PUBLIC INTEREST REVIEW FOR GROUNDWATER APPLICATIONS

TO: Water Rights Section Date August 18, 2016  
 FROM: Groundwater Section Aurora C Bouchier  
Reviewer's Name  
 SUBJECT: Application G- 18294 Supersedes review of na  
Date of Review(s)

**A. GENERAL INFORMATION:** Applicant's Name: Robert W. Gabriel Trust County: Marion

A1. Applicant(s) seek(s) 0.45 cfs from 3 well(s) in the Willamette Basin,  
Middle Willamette subbasin

Water-Level Trends in Nearby Wells

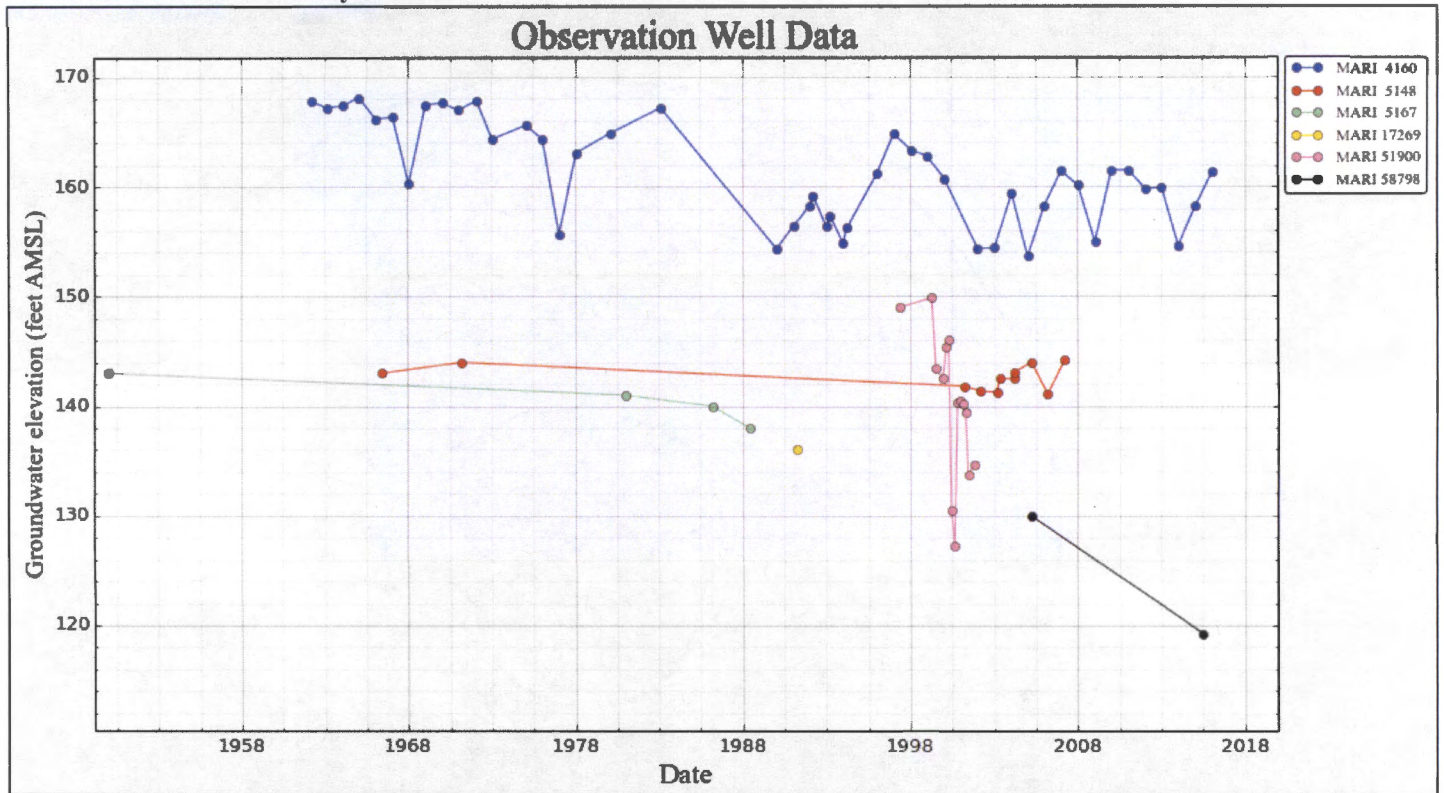
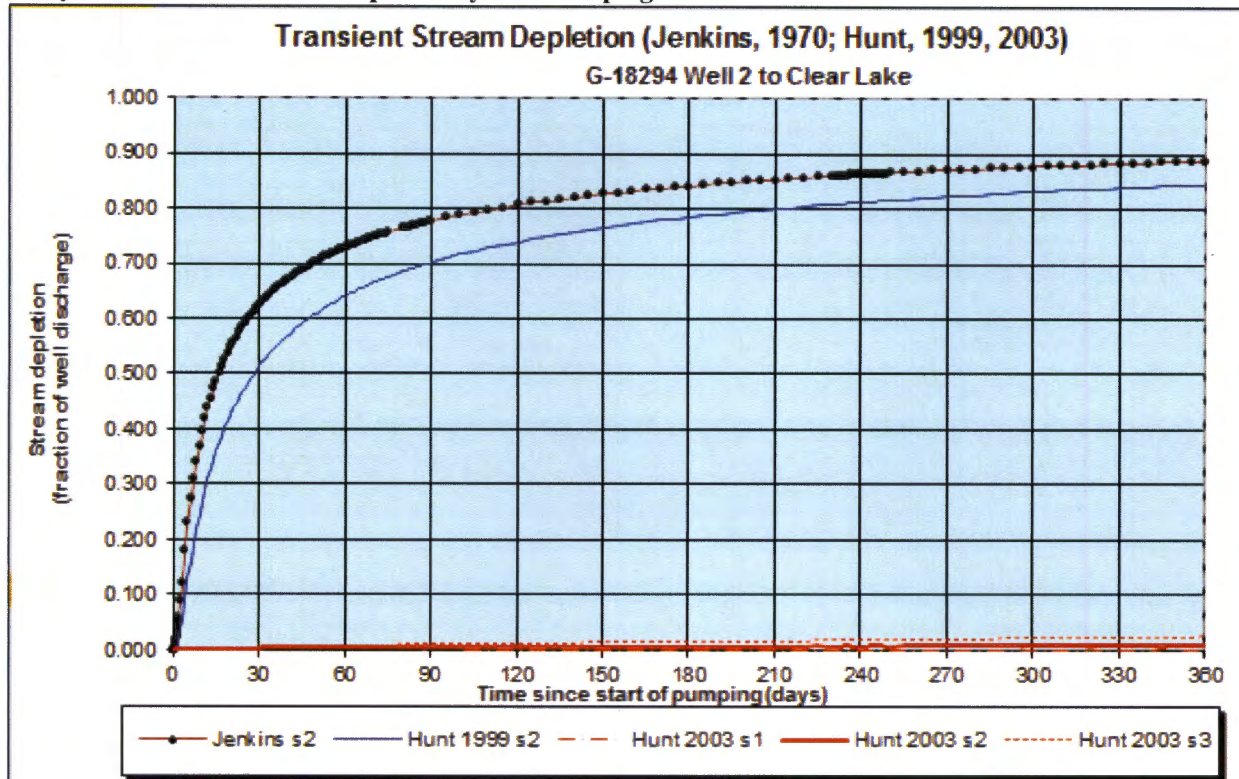
Observations from nearby wells indicate relatively stable long-term trends for alluvial wells in the immediate area of the proposed wells (see attached hydrograph), but increased groundwater development in the area indicates a need for additional water-level monitoring. In addition, the stated reason for related Transfer T-12361 is that “Production from the authorized Well 2 (MARI 17269) has decreased over time and no longer completely supplies our needs...” It is possible that the decrease in production is a result of decreased well efficiency. However, this speaks further to the need for additional water-level monitoring.
